Project Name, If Applicable: The O'Hara Residence

Project Street Address: 15 Dusenberry Rd, Bronxville, NY 10708

PLAN REVIEW COMMENTS

DESCRIPTION OF WORK : Front portico/kitchen/dining/family room/mudroom addition design at first floor and master suite/bedroom/bathroom addition design at second floor.

PROPOSED PLOT PLAN

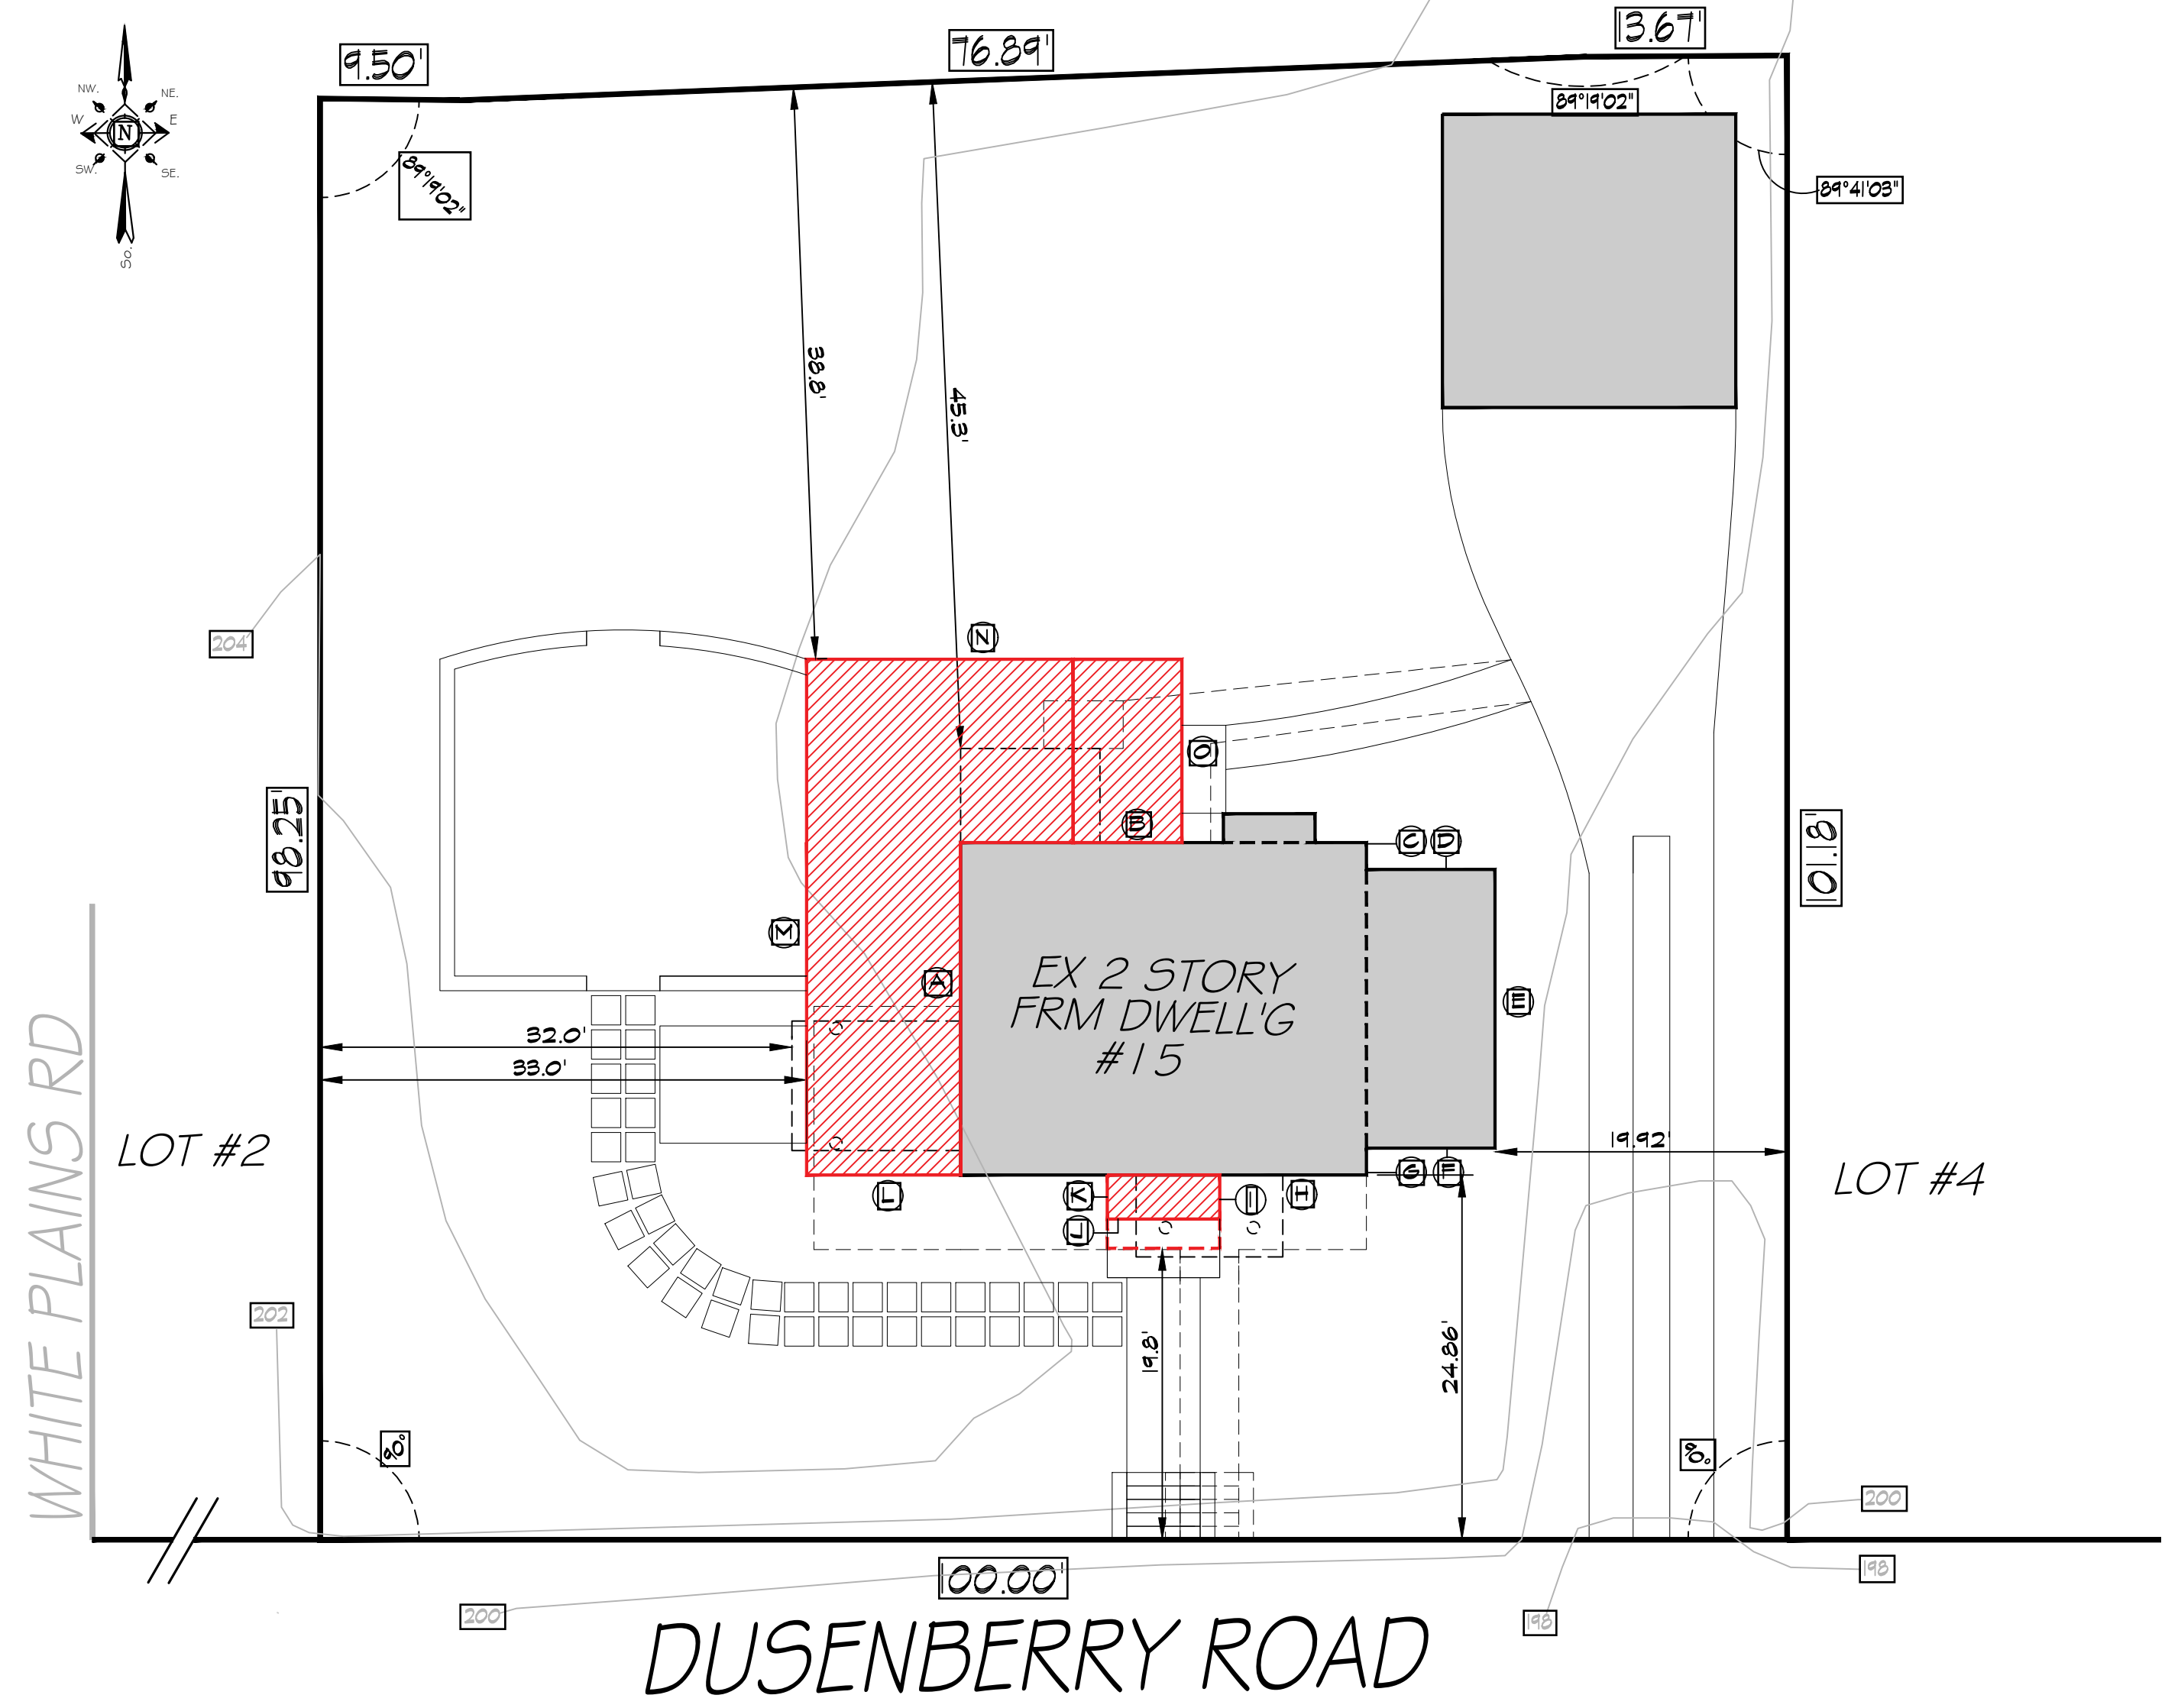
- 1) Building Coverage as per 310-10 exceeds maximum 22 1/2 %
- 2) Front Yard setback - 30', proposed front yard setback 19.8"
- 3) FAR (proposed) is .25. Existing FAR - .15; 30% maximum increase = .045; proposed increase = .195. As per 310-26 D (1) (b) [1] maximum FAR increase is 30%, proposed work exceeds the maximum 30% FAR Increase

As per 1 & 2 above referral to zoning is required

As per # 3 above referral for site plan development is required.
